From: GCC Corporate Mail <gccmail@gcc.tas.gov.au>
Sent: Wednesday, 2 August 2023 4:16 PM
To: TPC Enquiry
Cc: Lyndal Byrne
Subject: Glenorchy - Draft Amendment PLAM-22-04 - Response to Directions (18 July 2023) prior to Hearing
Attachments: ECM_3278143_v8_PLAM-22_04 - Response to TPC preliminary assessment matters.pdf; PLAM-22_04 - Response to TPC preliminary matters - Attachment 1. MODIFIED Instrument of Amendment.docx; PLAM-22_04 - Response to TPC preliminary matters - Attachment 2. MODIFIED DRAFT Amendment .docx

Our ref: PLAM-22/04
Enquiries: Angela Dionysopoulos, Strategic Planner
Phone: (03) 6216 6800
Email: angela.dionysopoulos@gcc.tas.gov.au

**RESPONSE TO TPC'S DIRECTIONS DATED 18 JULY 2023
TASMANIAN PLANNING SCHEME – GLENORCHY - DRAFT AMENDMENT PLAM-22/04
PROPOSED SPECIFIC AREA PLAN – PRINCIPAL ACTIVITY CENTRE**

Figure 1 – Land within the waterway and coastal protection area (blue hatch), proposed to be rezoned from UZ to CBZ – marked-up snapshot from LISTmap.

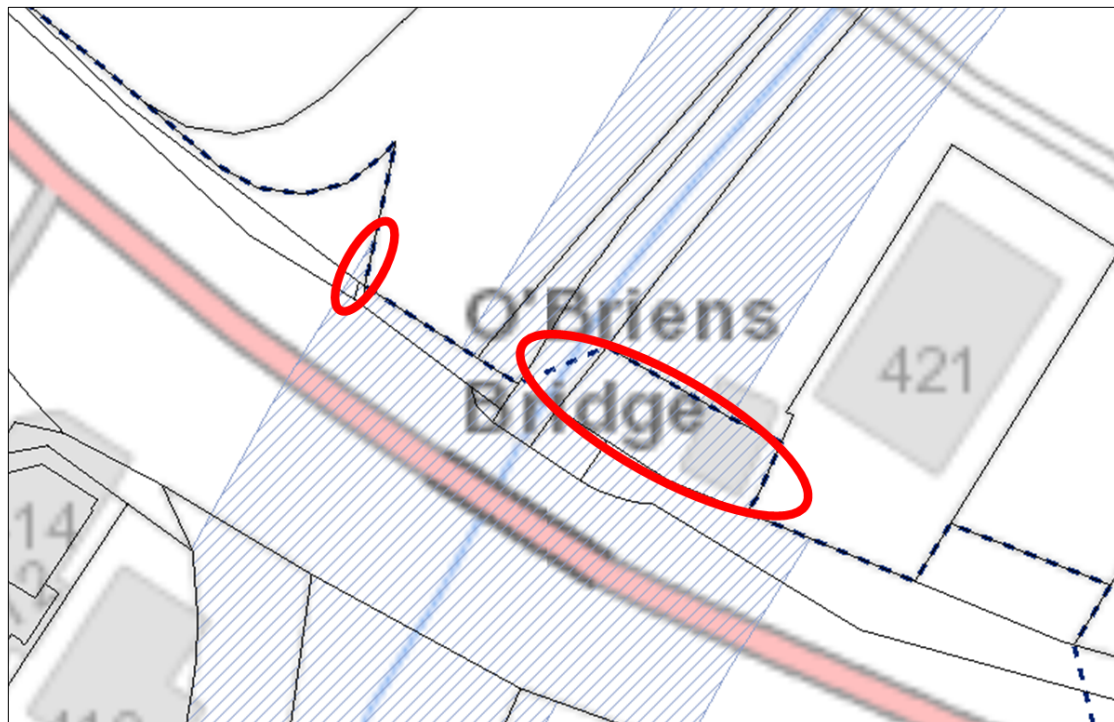
- 1. The planning authority is requested to submit an expanded consideration for the proposed rezoning of land from UZ to CBZ with reference to the section 34(2) LPS criteria of the Land Use Planning and Approvals Act 1993 (the Act).*

The proposed rezoning is minor in extent and nature. It will not cause the LPS, as amended, to cease to meet the LPS criteria, as follows:

The proposed rezoning will not cause the LPS to no longer further the objectives set out in Schedule 1. The rezoning will further the orderly use and development of land, by ensuring that the facades of existing buildings are within the same zone as the remainder of the building. The rezoning will not impact on Council's rights within the road reserve, in order to develop and manage the public road asset.
